BEFORE THE HON'BLE NATIONAL GREEN TRIBUNAL,
WESTERN ZONE BENCH, PUNE
APPEAL NO. 05 / 2025

Union of India & Ors. ... Respondents

REPLY AFFIDAVIT BY RESPONDENT NO. 2,
STATE ENVIRONMENT IMPACT ASSESSMENT AUTHORITY

Drain Detail at the end of the Road

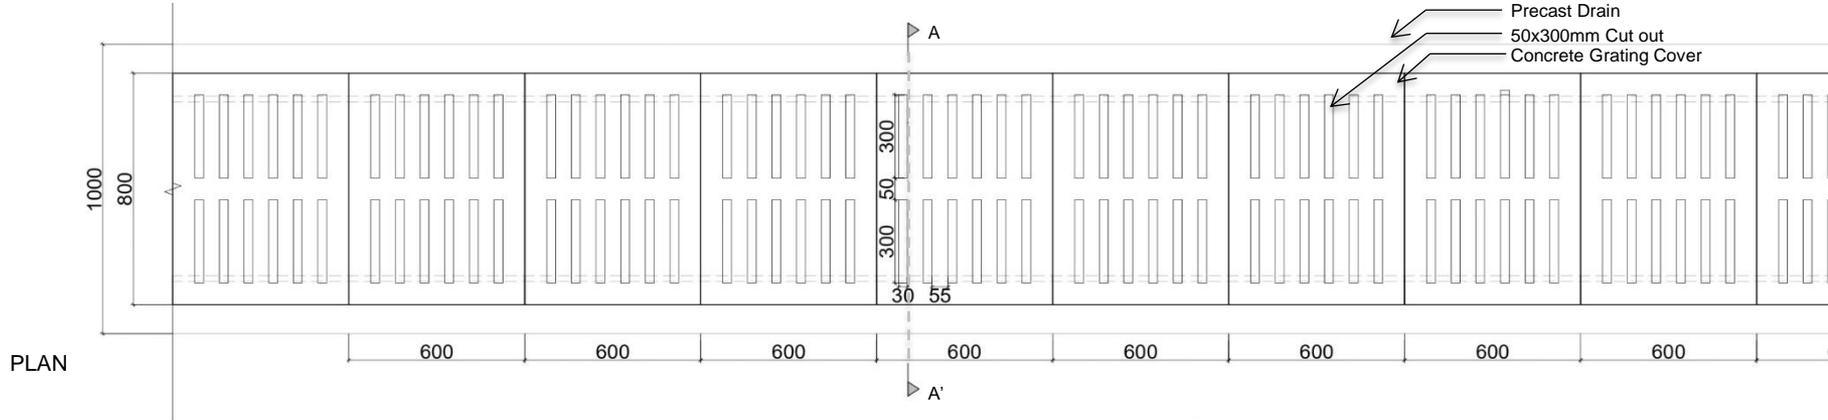
COMPLIANCE POINT NO 5: PP to submit the Hydraulics study or effect of RFD on natural storm water disposal into Mula- Mutha river.

g. However, during the flood in river, retention of flood within nallah shall be ensured to avoid submergence of urban areas due to backwater effect.

f. Those stretches will be provided with swales running parallel to the embankments along the city side up to the next nallah or would have provisions of outfalls at strategic locations. The locations and dimensions of these swales would be finalized during the detailed design stage.

Open Swale provided along the back slope of the embankment

Closed Swale Detail near residential areas

600 x 450mm Precast Chute laid at the termination of the pipe.

Non-return Flap Valve provided at the drain to resist the flow of water from the river to the City side.

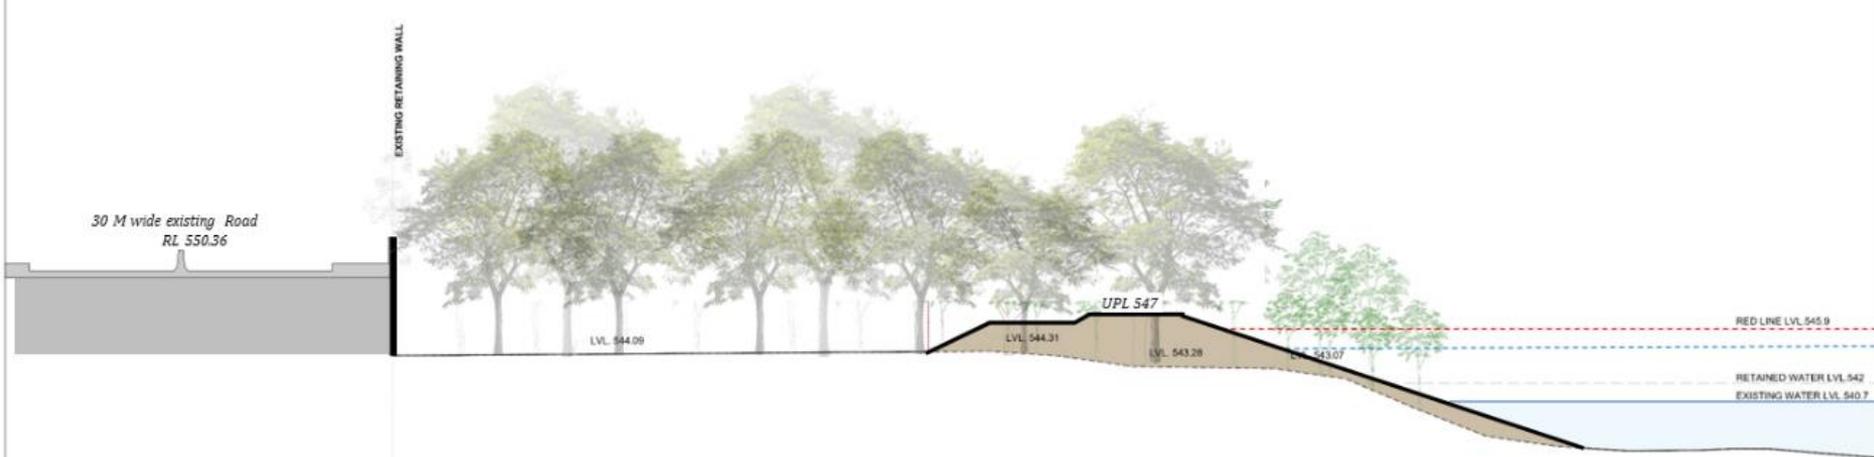
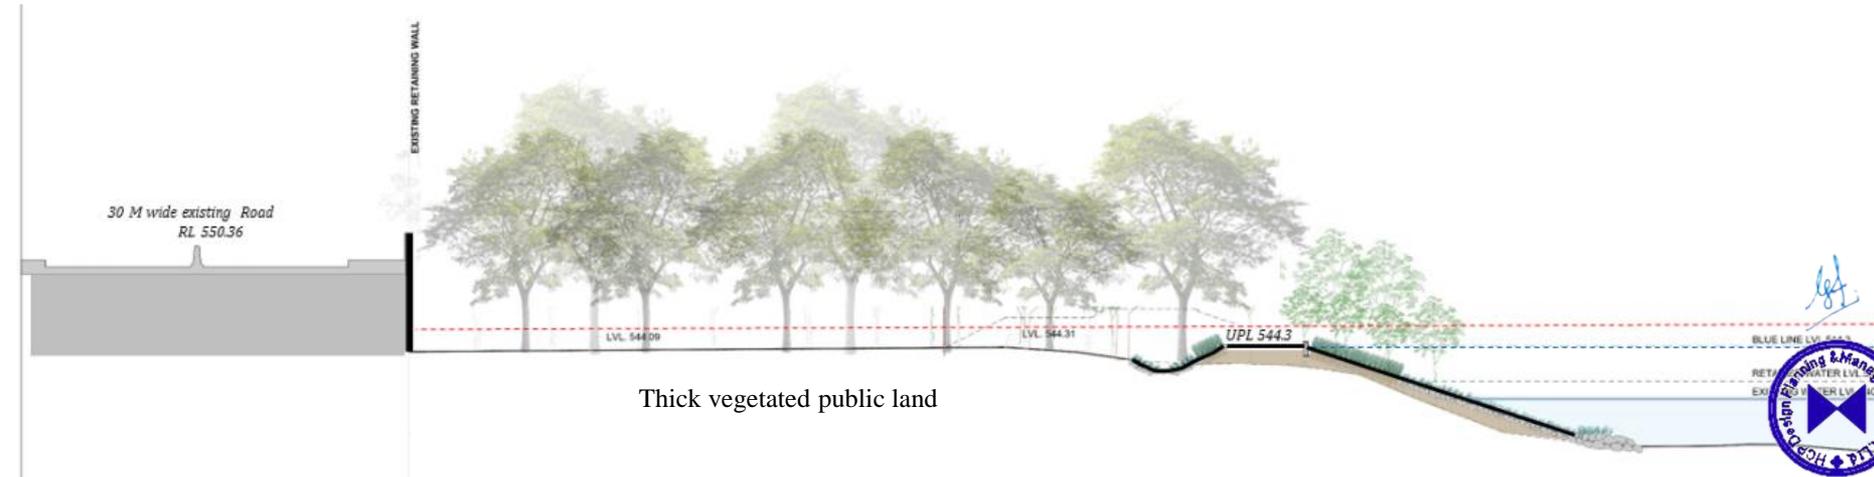
COMPLIANCE POINT NO 9: During Monsoon even if there are no much floods in rivers due to existing dams and controlled releases from upstream reservoirs ,now a days high intensity short duration events like 2019 pluvial floods , (floods in city area due to direct surface runoffs and natural drainages in city area) are occurring frequently , Hence after raising Embankments above ground levels, the arrangements for storm water drains must be ensured with planning of connecting surface water to nearest nalla/ drains and direct surface access towards rivers must be ensured with provision of water entry points in design of parapet walls and raised embankments. To avoid such city surface runoff inundations, thought must be given to limit height of embankments wherever possible and avoid embankments above the ground level.

i. Height of embankment up to red line protection

ii. Height of embankment reduced to blue line protection considering the site conditions and feasibility.
